Re: HVO Continuation Project - Response to supplementary advice

Re: Hunter Valley Operations Continuation Project - Response to supplementary advice on water licensing and waterfront land

HVO Continuation Project
Figure 3.1

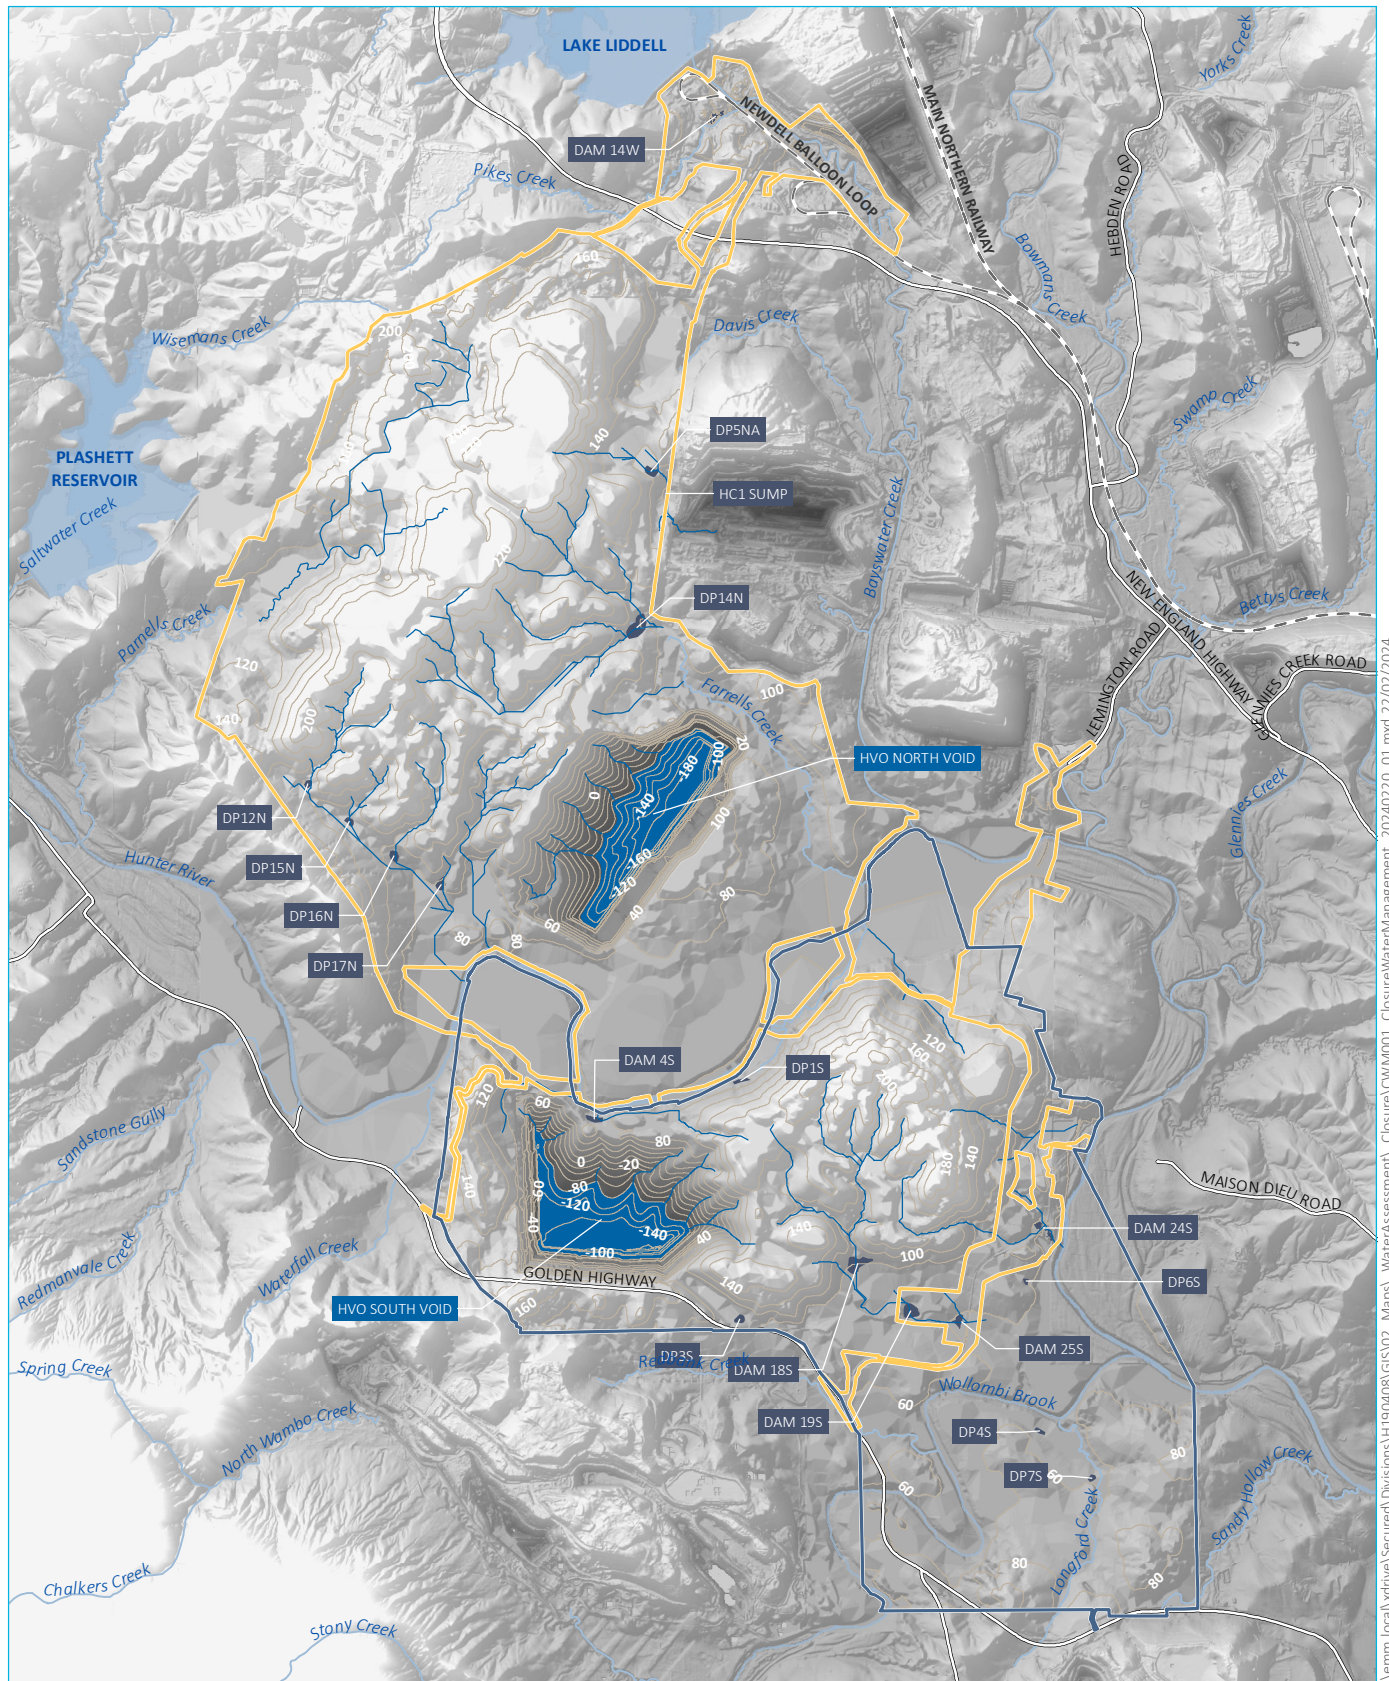
The proponent should review the water licensing requirements for dams where diversions are existing or proposed and the dam still captures runoff.

Section 4.3 of Appendix D to the response to submissions (RTS) report has referred to a number of dams as off-stream storages after construction of diversions. Should these dams still have a catchment which is a source of runoff (i.e. not a turkeys nest dam), this water take and/or the dam itself needs to be assessed for licensing or a relevant exemption.

Figure 3.1 presents the conceptual locations of water management structures established on drainage lines within the final landform. During the closure period, these storages will act as sediment dams to control runoff water quality by retaining sediment until adequate vegetation cover is established. Post-closure, when the vegetation cover criteria have been met, the dams will be decommissioned, retained as harvestable rights dams (if on minor streams) or retained with the required water supply work approvals acquired (if on non-minor streams).

Table 3.4 summarises the water management structures proposed for the closure period. Using the amended drainage configuration (i.e. final landform drainage lines), there are a total of 14 dams located on minor streams (i.e. first or second order streams or not located on a stream), with the remaining four dams located on third order (i.e. non-minor) streams.

1. Based on the amended drainage configuration within the final landform as shown on Figure 3.1.

HVOP-WSP-55.01.02.02-TR-0001

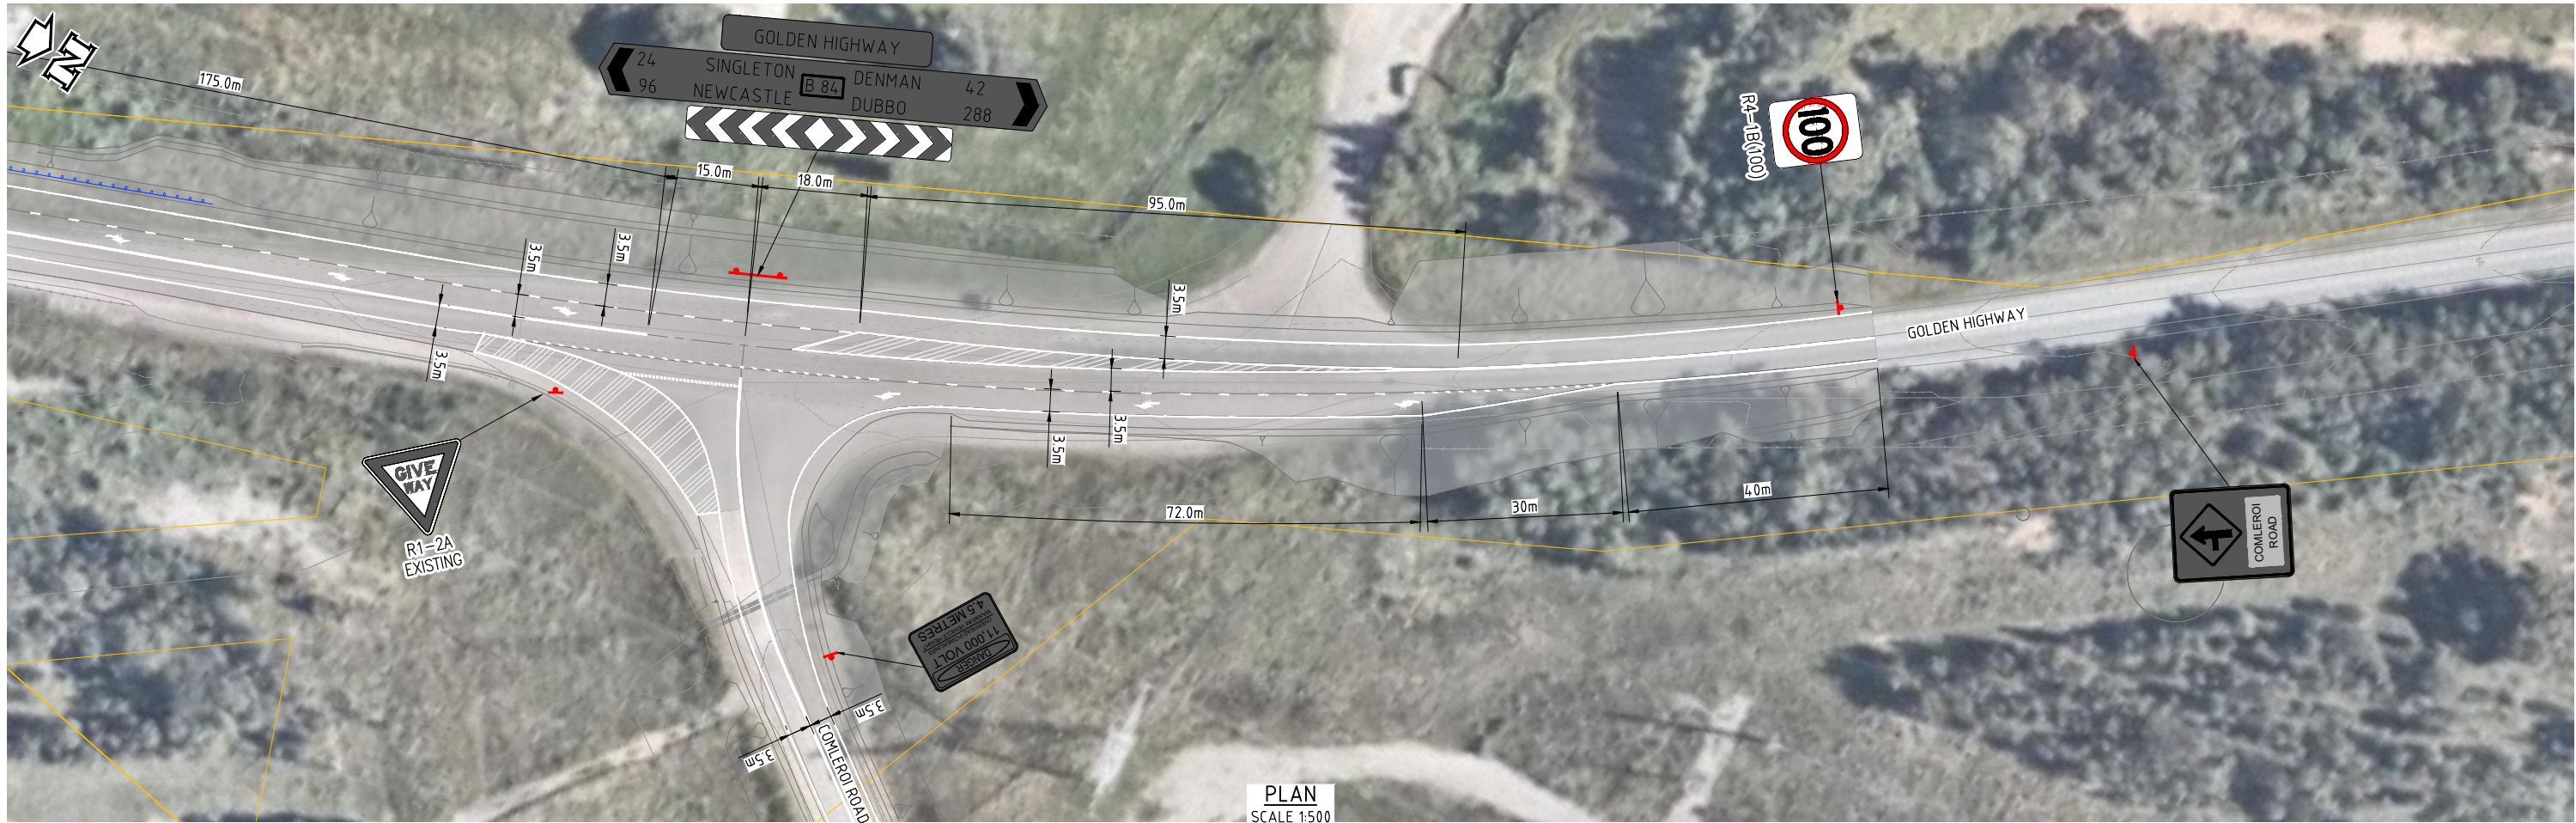
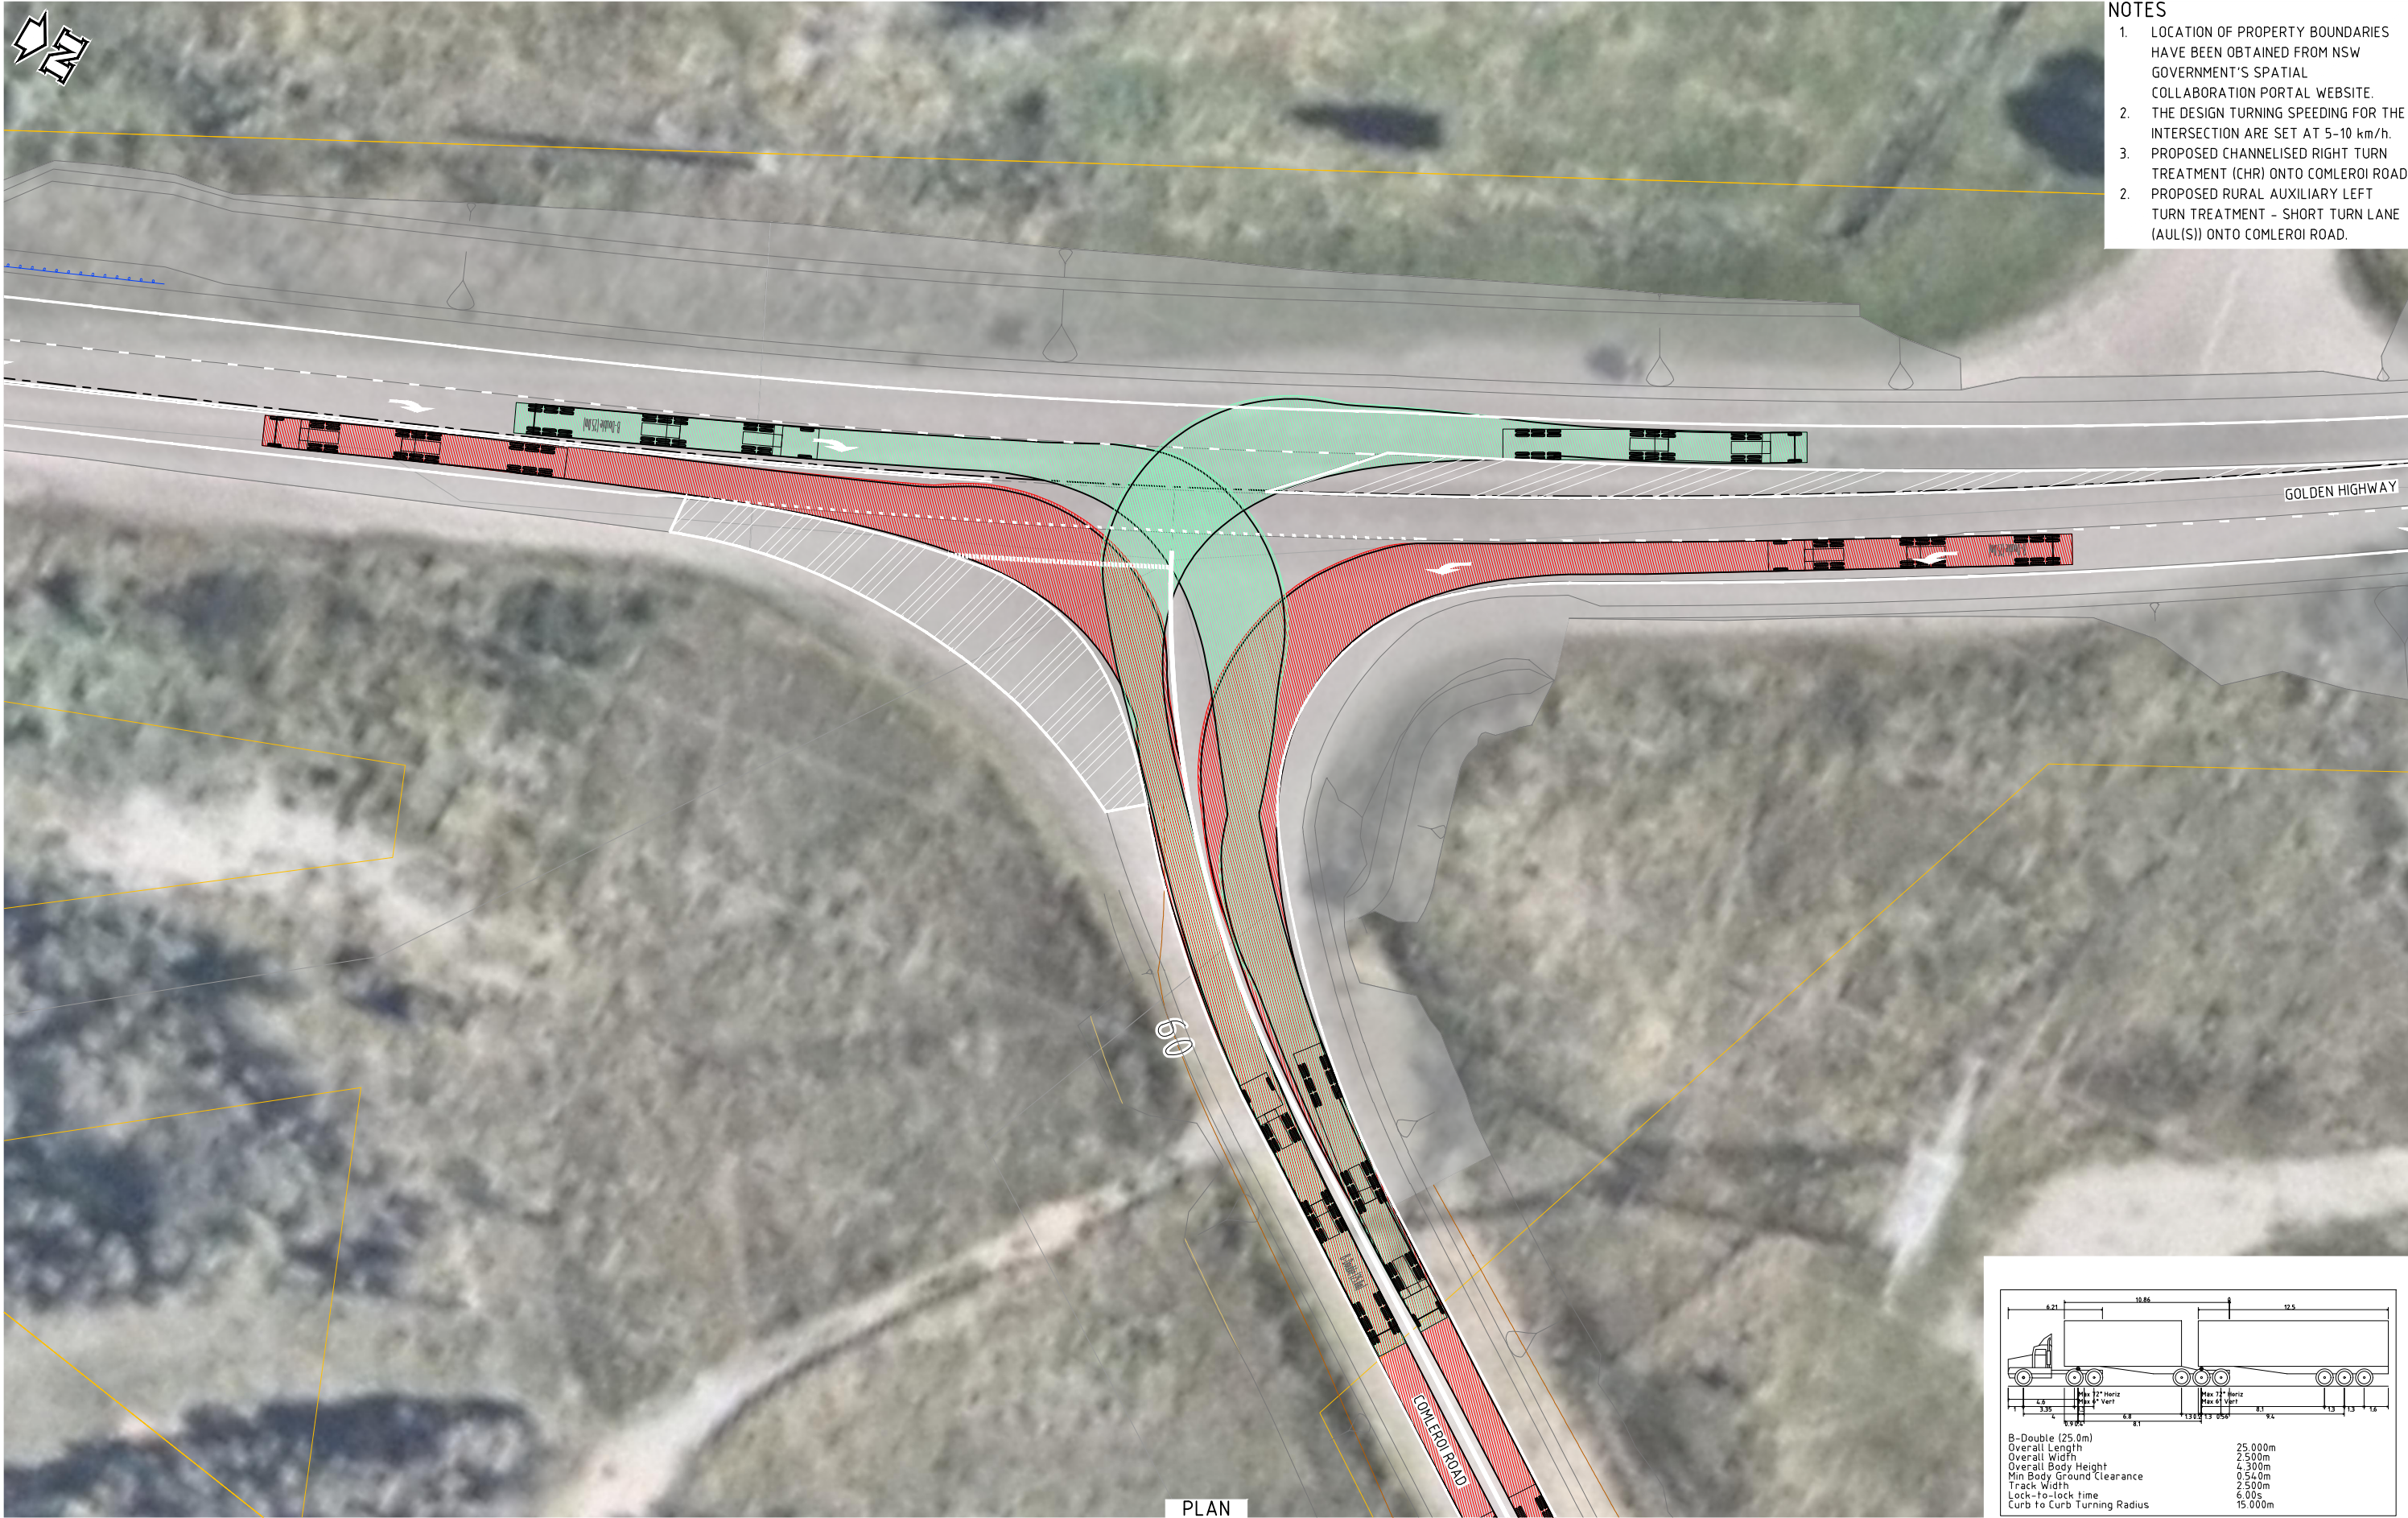
TfNSW further noted that they had previously requested a Strategic Plan for the proposed upgrade of the existing Golden Highway/Comleroi Road intersection which had not been provided and TfNSW were unable to fully clarify the necessary scope of development works, and subsequent Environmental Assessment for DPE's consideration.

In response to this matter raised by TfNSW, a strategic plan for the preferred upgrade of the existing Golden Highway/Comleroi Road intersection has been provided as Appendix B. As noted within the EIS (Section 4.4.1), the Project allows for two options with respect to the connection to the Golden Highway; one assuming that the Golden Highway is realigned by United Wambo State significant development (SSD) 7142 as approved, and a second option that aligns with the current alignment of the Golden Highway. At this time, it is assumed the intersection will be constructed along the current alignment of the Golden Highway, which is reflected in the strategic plan provided in Appendix B.
